**Millbrook Subdivision, 396 County Road 10, Fallis North, Township of Cavan Monaghan,  
County of Peterborough**

GHD Limited has prepared the following responses to the review of our Environmental Impact Study (dated August 7, 2025) by Stantec, the Township's peer reviewer for the first submission of the draft plan of subdivision for the property located at 396 County Road 10, Millbrook in the Township of Cavan Monaghan, known as Fallis North. The peer reviewer requested additional ecological information and clarifications on the Environmental Impact Study in their October 17<sup>th</sup>, 2025 peer review letter.

**Updated EIS Figure 1 - Natural Features,  
Surveys and Constraints**

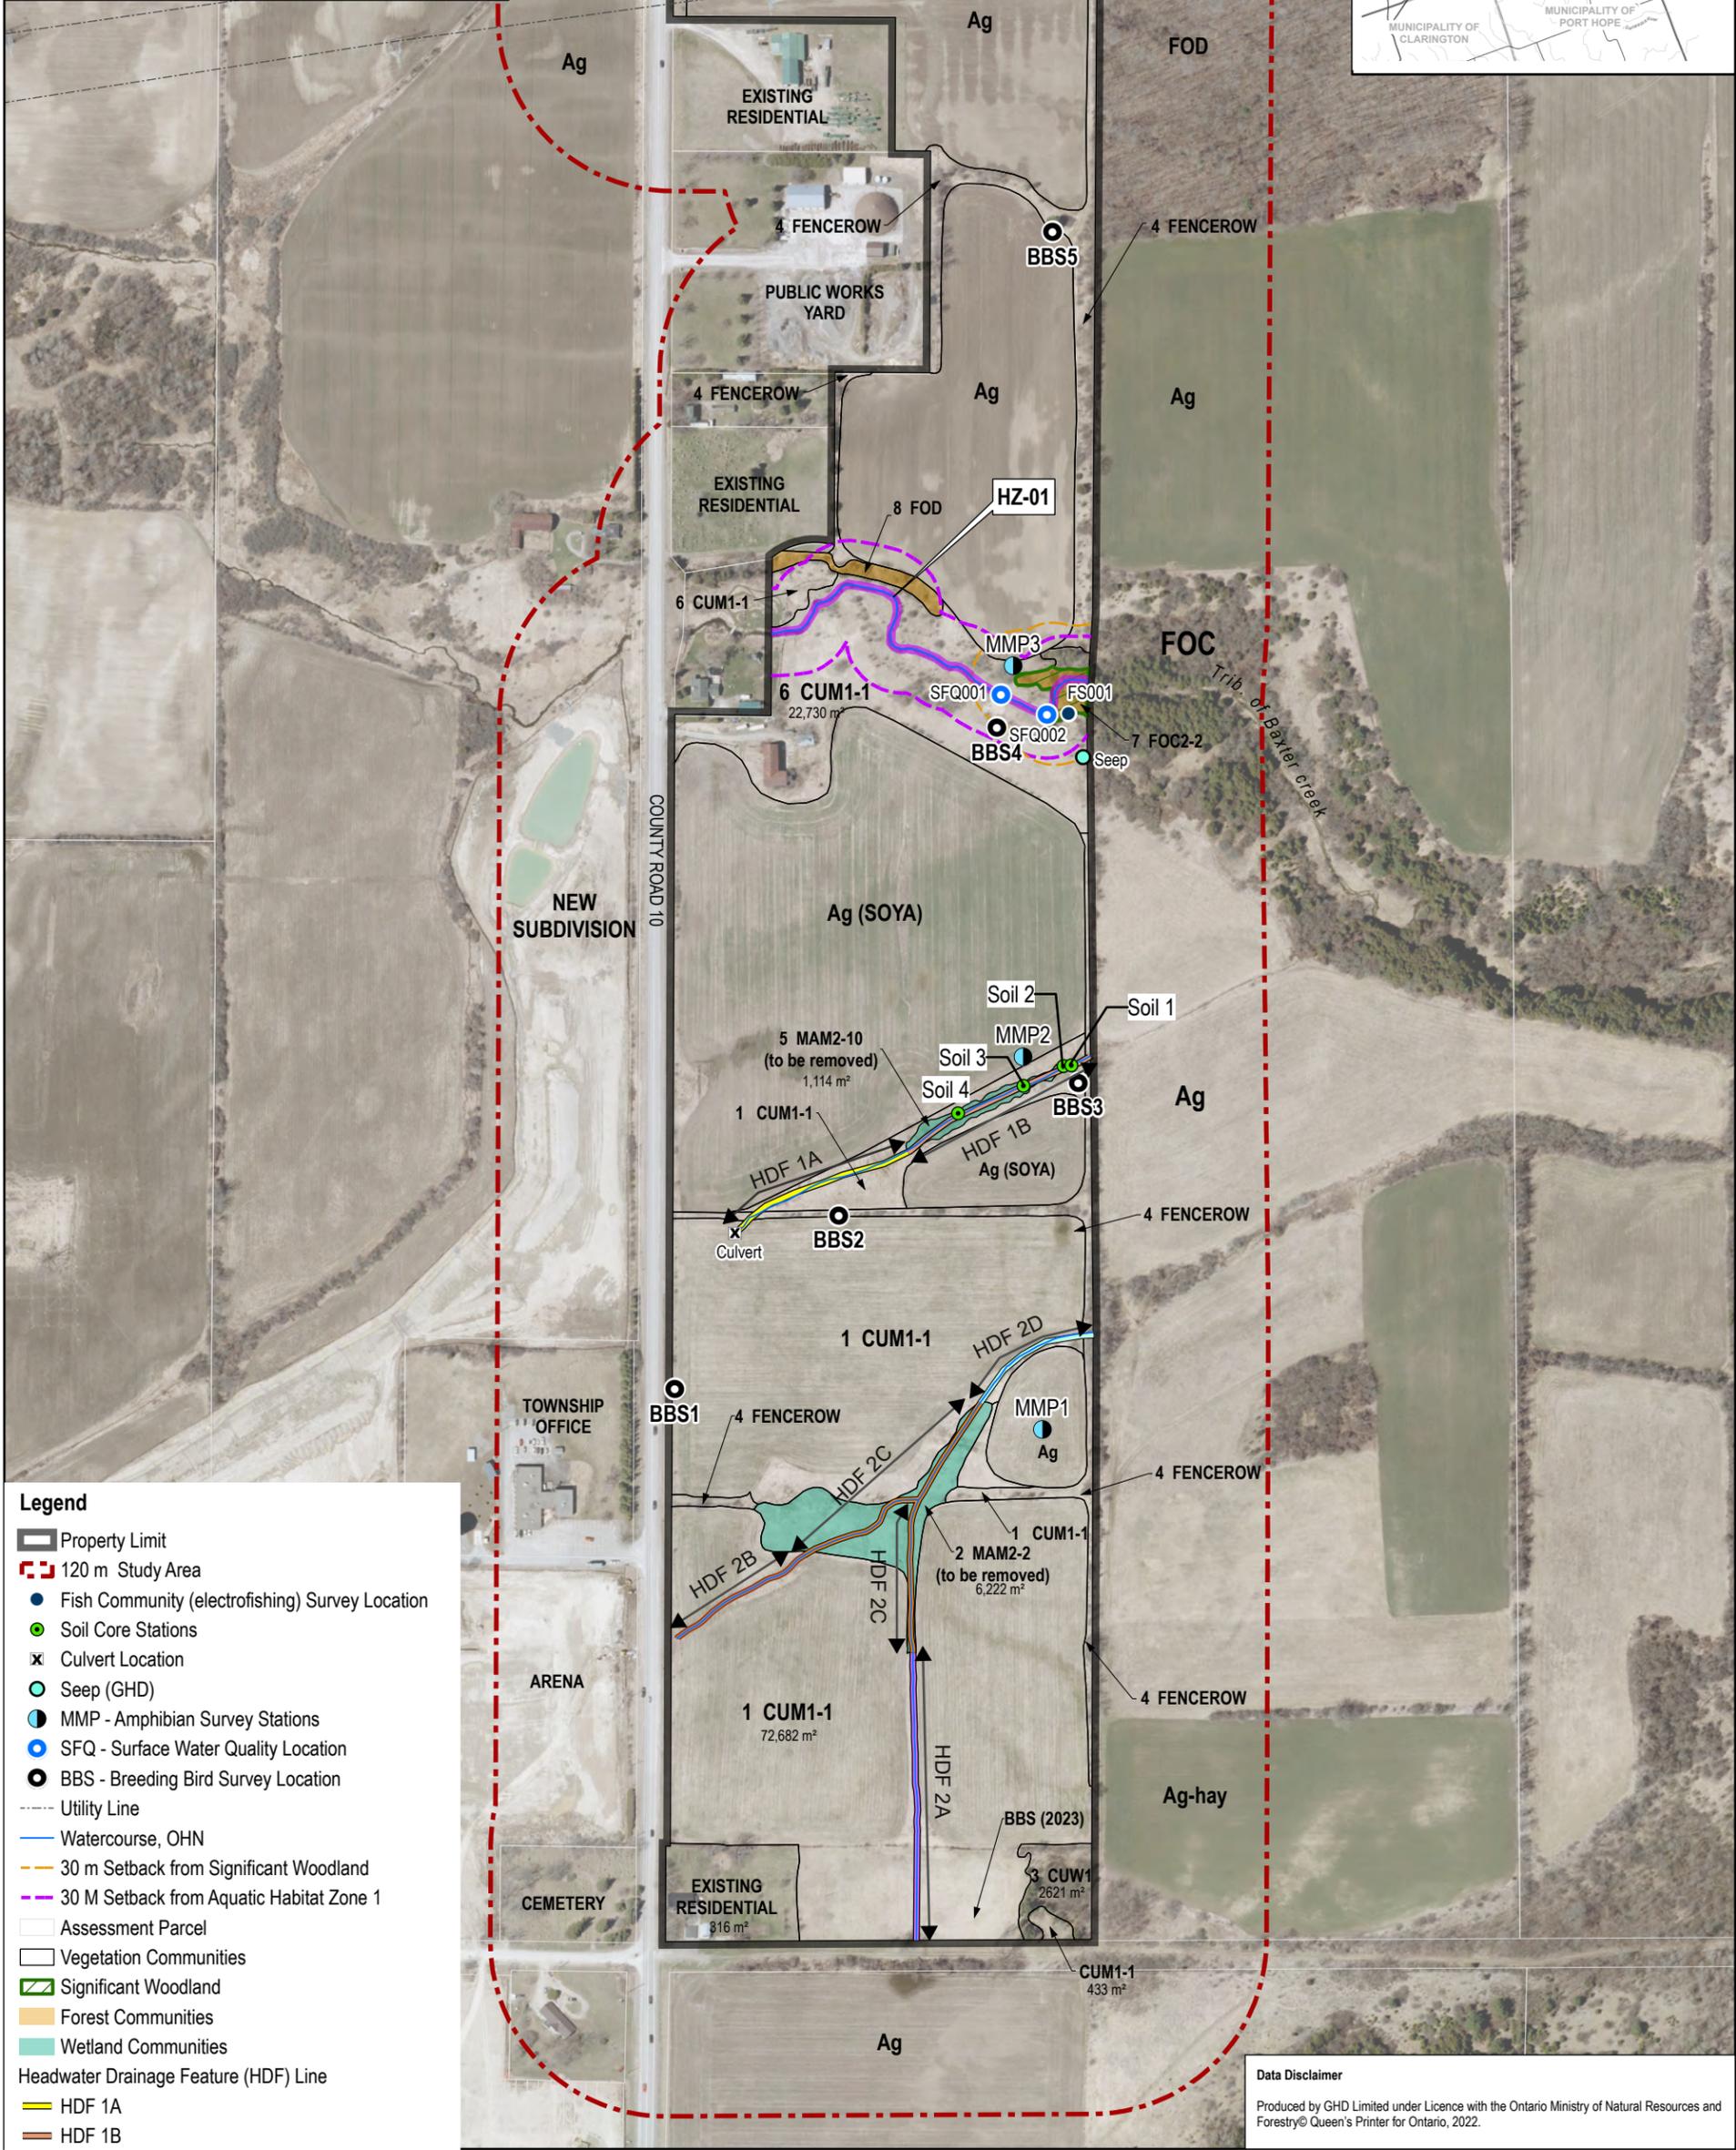
***Stantec Comment #10: The majority of the subject property was composed of cultivated agricultural land (Ag) or Dry Moist Old Field Meadow (CUM1-1) with some smaller inclusions of forest (FOC2-2, FOD and CUW1) and mineral marshes (MAM2-10 and MAM2-2). It is noted that no results were provided for the Study Area, beyond the immediate property. It is recommended the mapping and results be provided for adjacent lands.***

***Stantec Comment #22: It was noted that the floodplain was identified on the Site Plan (Appendix A) but was not included in Figure 1 and/or discussed as part of the EIS. It appears to encroach on the 30 m buffer on the Site Plan (Appendix A). The floodplain limit should be shown on Figures 1 (and a new Figure 2) as a constraint. A permit will be required from ORCA for activities in the floodplain.***

***GHD Response:*** The surrounding lands within 120 metres of the Site are predominantly rural residential, institutional, recreational and agricultural. Some naturalized areas to the east include ELC codes such as cultural meadow (CUM1-1), deciduous forest (FOD) and coniferous forest (FOC). The figure has been updated to show either land uses or ELC Ecosite codes in the 120 m adjacent lands.

**GHD Response:** The latest Site Plan has been overlaid on our Figure 1 to show those uses and the impact of that infrastructure on the natural features and recommended buffers.

**New Figure 2 - Natural Features and Site  
Plan Overlay**

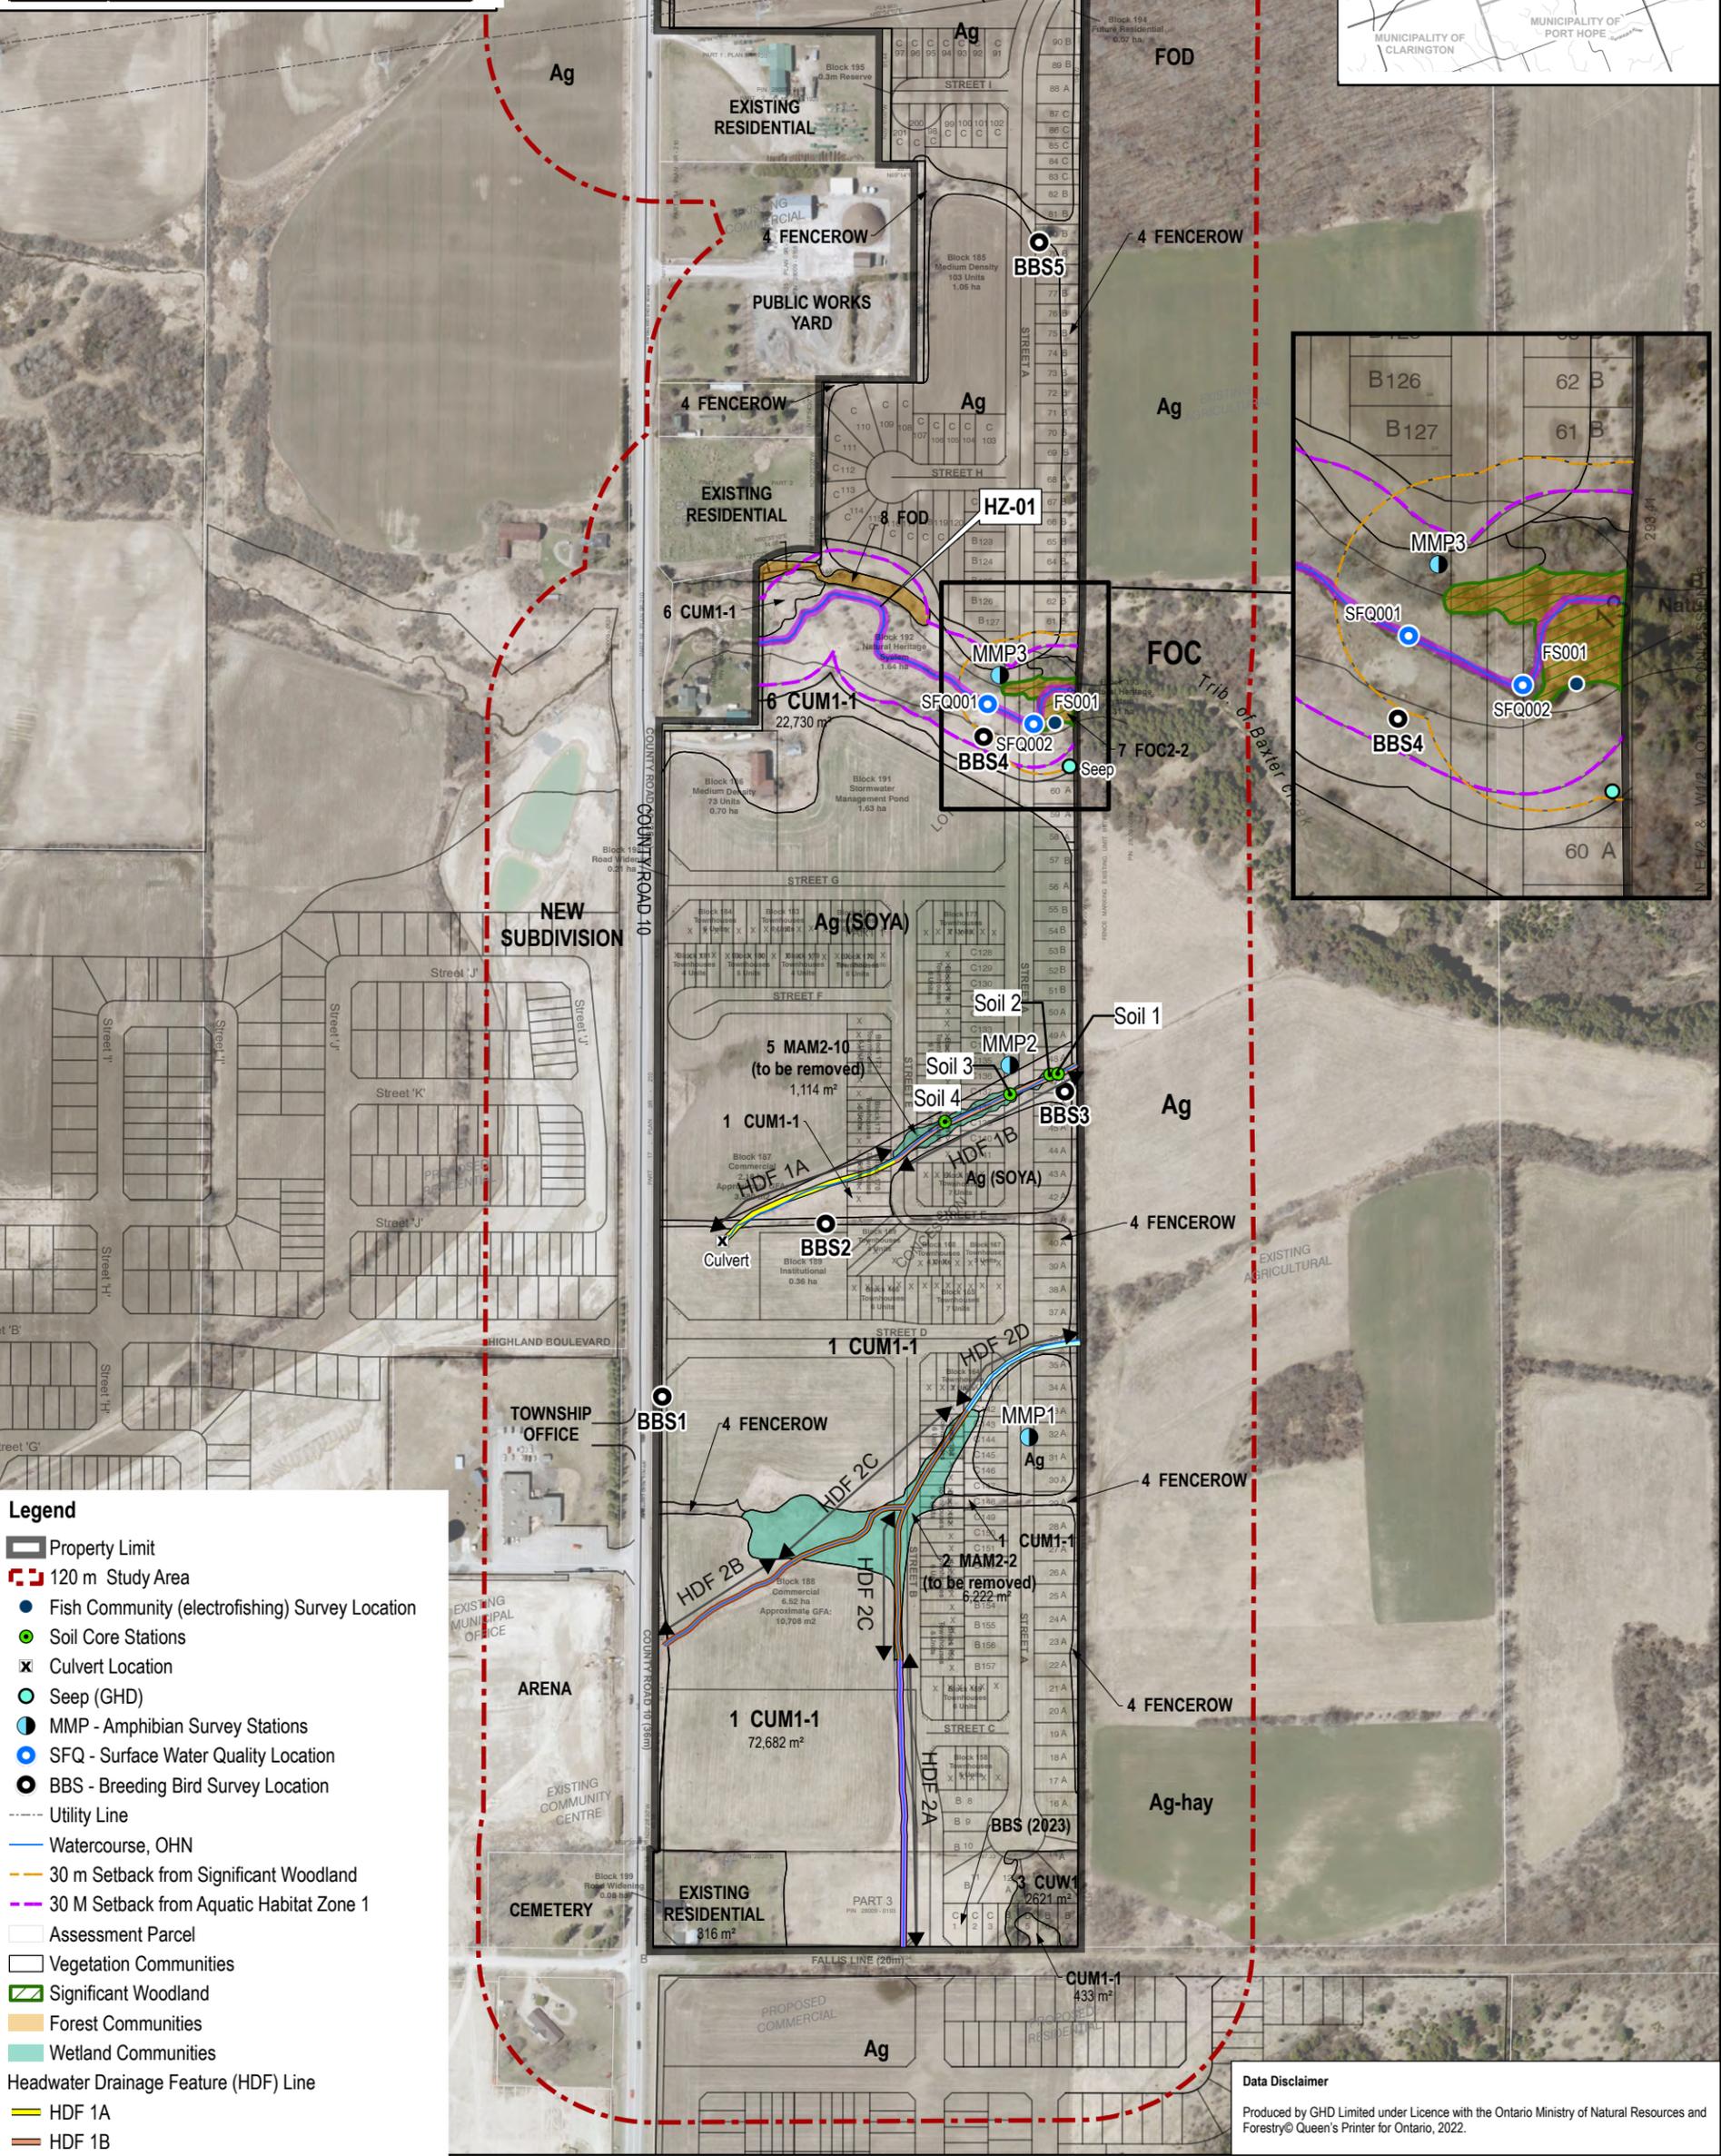
**stormwater management pond outlet, watercourse crossing and associated watercourse realignment as shown in the Project site plan (Appendix A).” However, it was unclear on the Site Plan, the location of the stormwater management pond outlet, watercourse crossing and associated watercourse realignment. Stantec recommends preparing a Figure that shows the proposed development footprint overtop of the existing natural heritage constraints identified in Figure 1.**

**GHD Response:** The latest Site Plan has been overlaid on our Figure 1 to show those uses and the impact of that infrastructure on the natural features and recommended buffers.
